# SALIDA SANITARY DISTRICT

## ADDENDUM NO. 1

### GRIT REMOVAL AND REPLACEMENT OF AERATION DIFFUSERS AND PIPING IN BASIN NO. 3

June 22, 2020

**PRE-BID CONFERENCE EXHIBITS  
OF ICEAS BASIN No. 1**

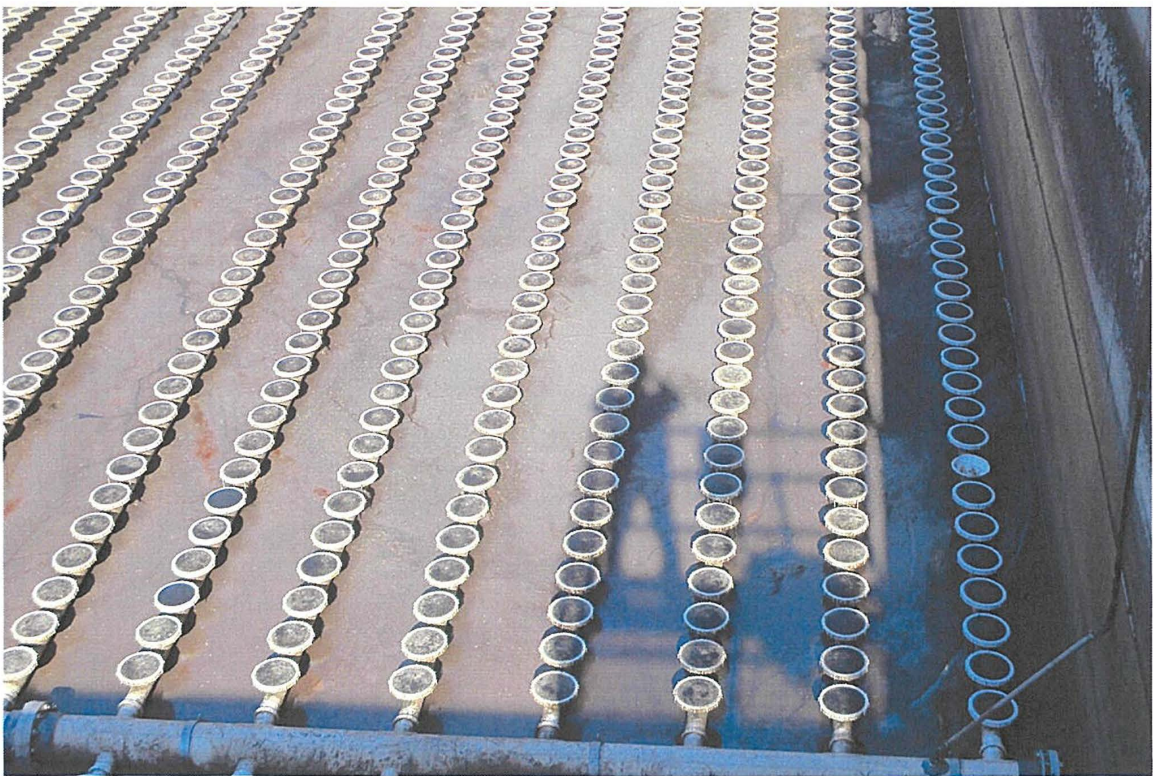
6. **Pre-Bid Conference**. The attached exhibits were distributed during the June 16, 2020 Pre-Bid Conference to give Bidders an estimation of the depth of sludge that might be found in Basin No. 3. The exhibits show depths of sludge from a similar project for ICEAs Basin No. 1, completed in 2019.
